# Access Compliance Report

## Public Rights-of-Way

Intersection ID: N/A	Main Street: KIMMERLY_GLEN_LN	Cross Street: ENDOLWOOD DR	Location: NE
ADA ID: 68DE68837990	Ramp Type: Directional1	Initial Pass/Fail: Fail	Overall Compliance: No
		Severity Score: 37.5

#### Codes/Mitigation Info/Possible Solution

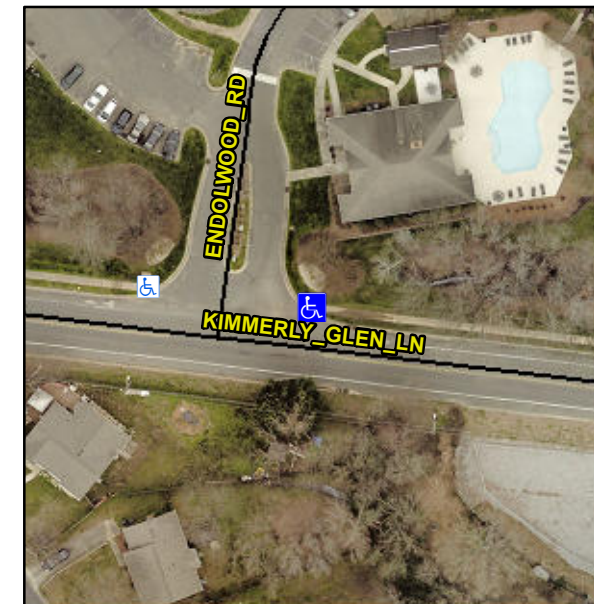
**DWS LCOATED ON LNDG**

**R304.2.2, R304.5.3**

**Remove & Replace Entire Ramp.**
